LTR: BYRON 2003-0064
File: 2.01.0700

Subject: Revision to the Reactor Coolant System Pressure and Temperature Limits
Report, Byron Station Unit 1 and Unit 2

**Byron Station Unit1 Reactor Coolant System Pressure and Temperature Limits Report
Revision 1**

**Byron Station Unit 2 Reactor Coolant System Pressure and Temperature Limits Report
Revision 1**

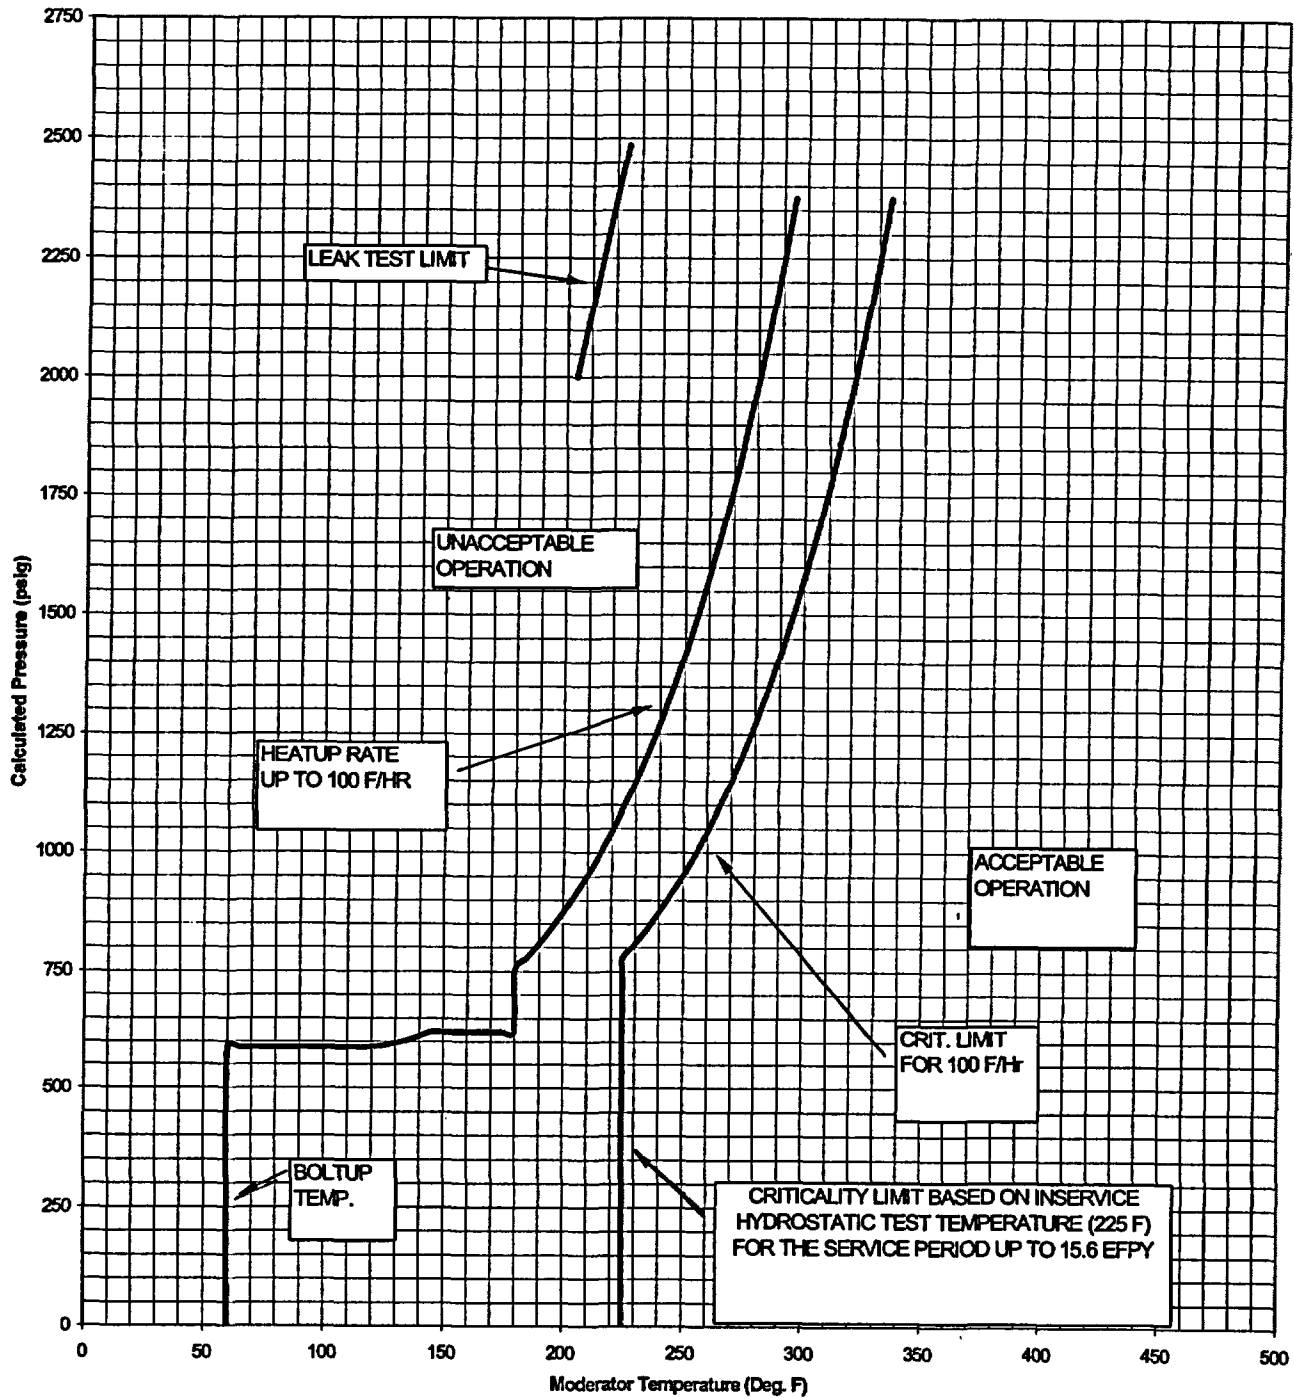
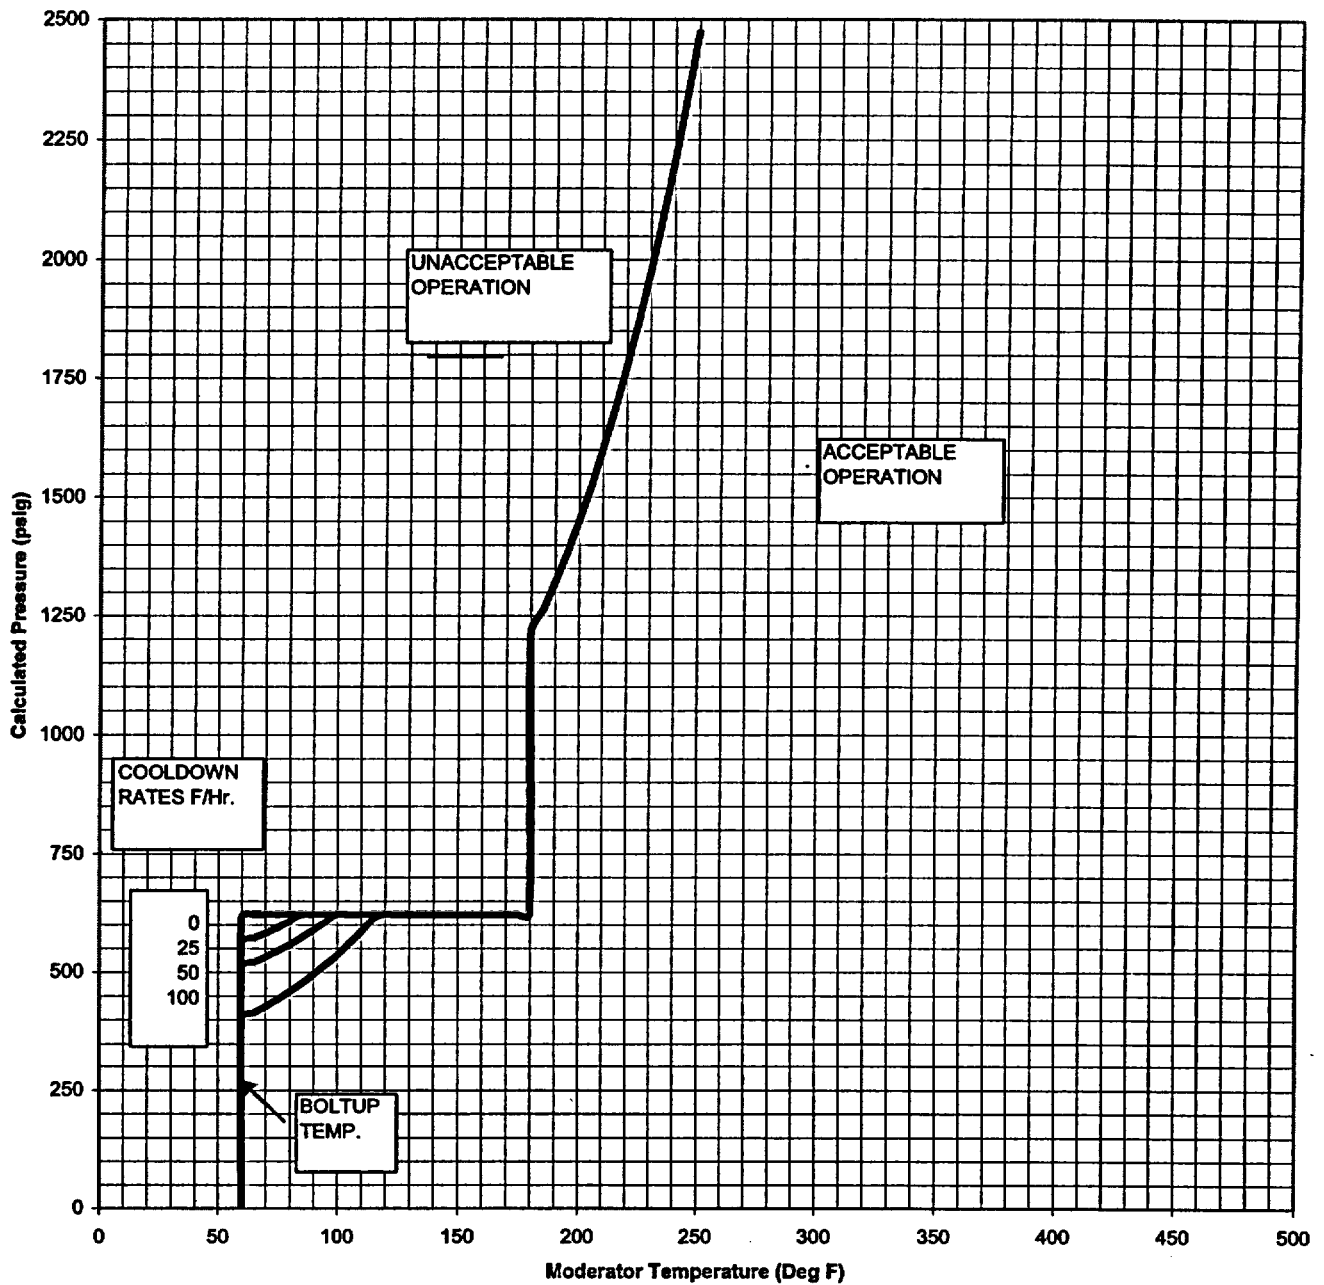
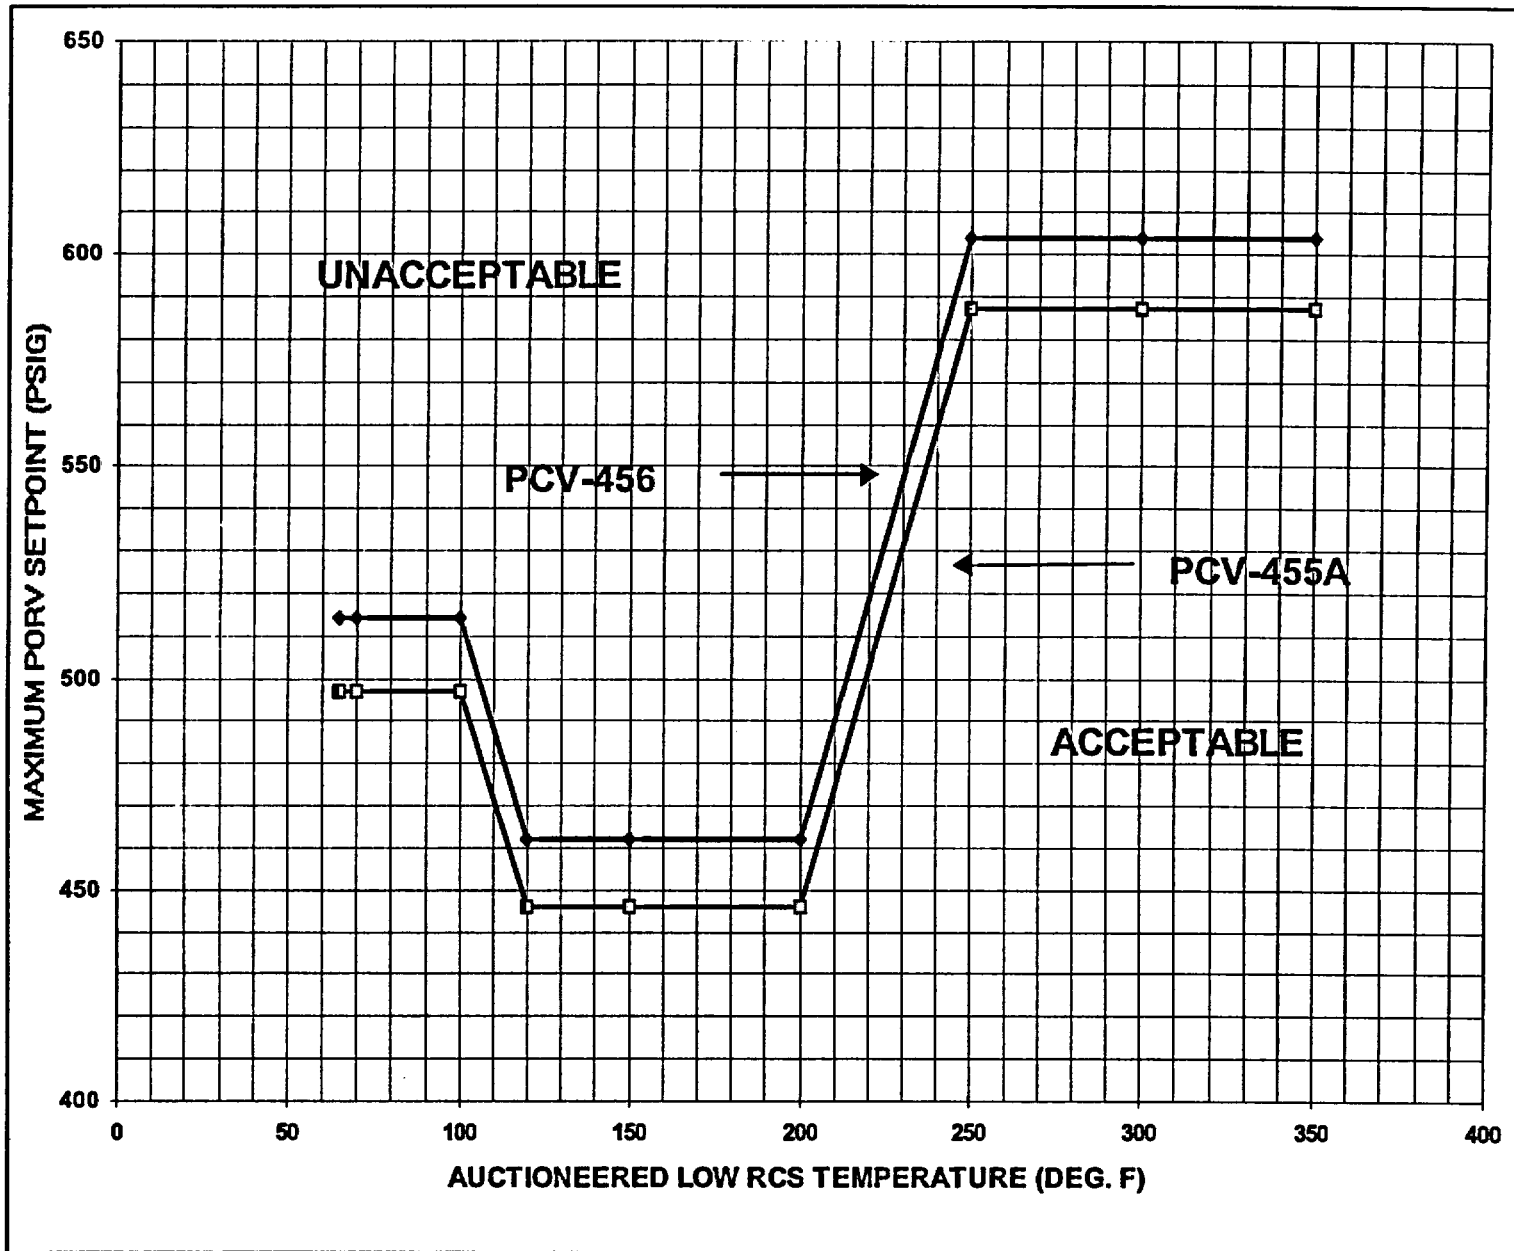
- The applicability for Figures 2.1, 2.2, and 2.3, and Tables 2.1 and 2.2 was revised from 16 to 15.6 EFPY. The applicable period is being revised due to power uprate impacts and the increased neutron flux.

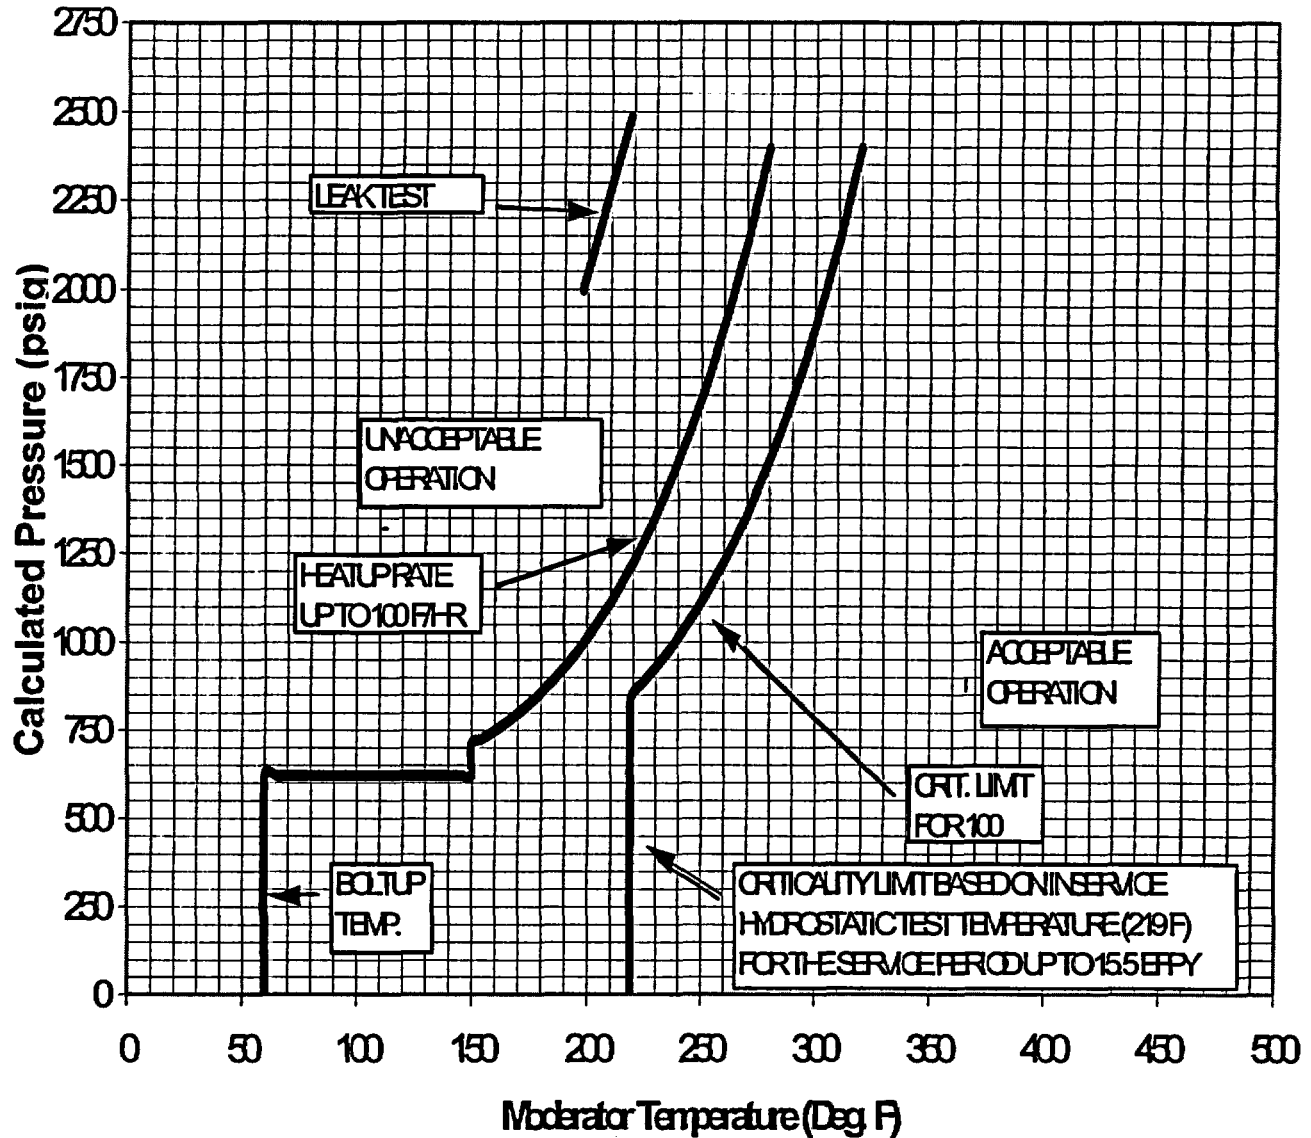
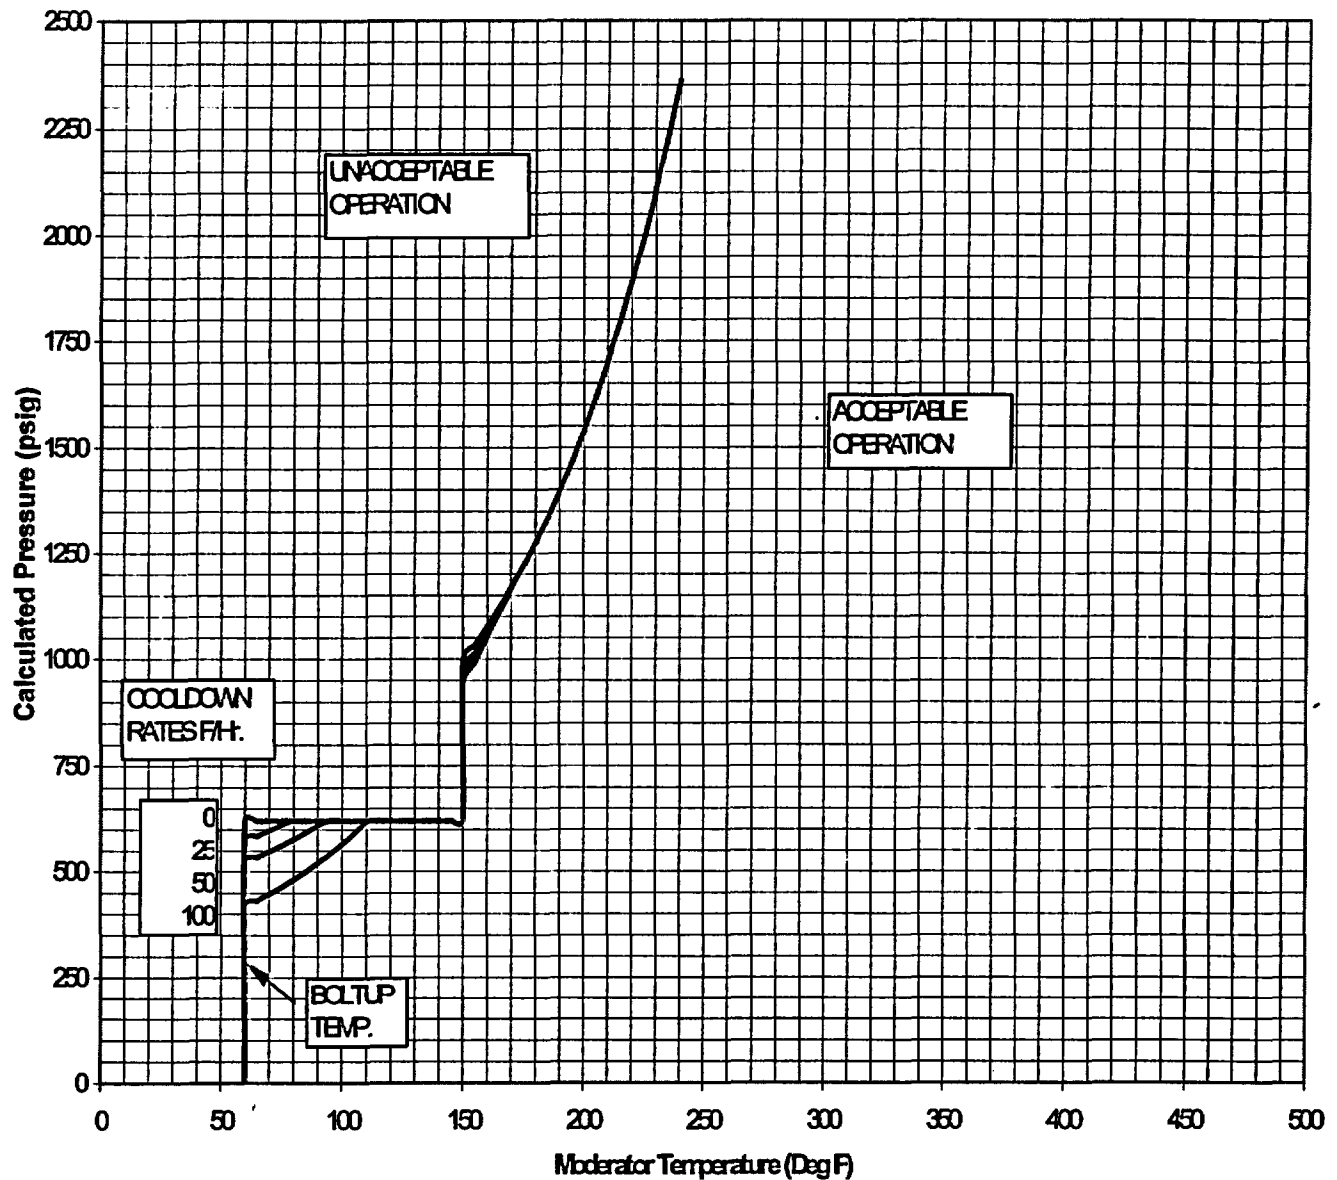
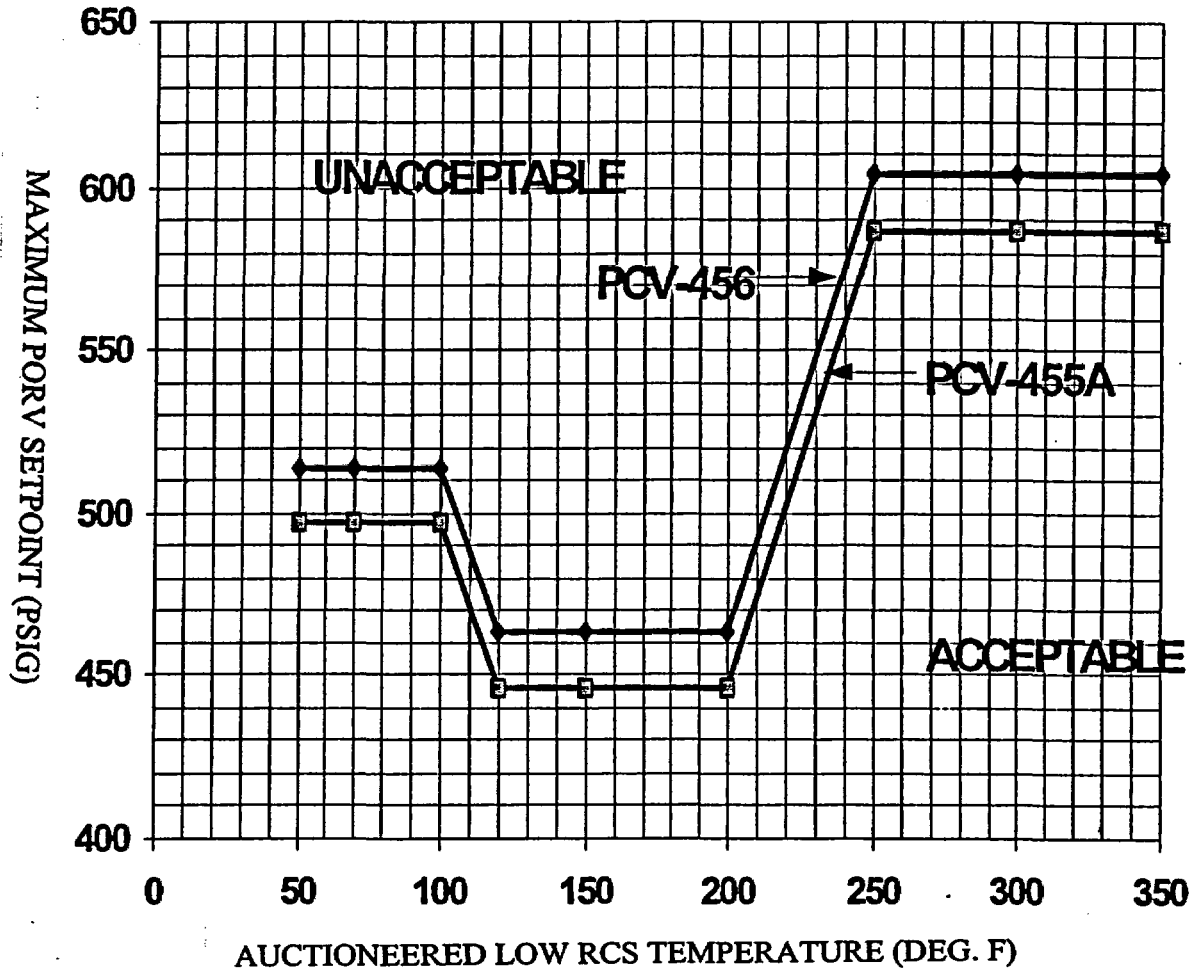
- Administrative/editorial changes were made to paragraph 1.0
- Reference 20 was added to paragraph 2.0
- The applicability for Figures 2.1, 2.2, and 2.3, and Tables 2.1 and 2.2 was revised from 16 to 15.5 EFPY. The applicable period is being revised due to power uprate impacts and the increased neutron flux.
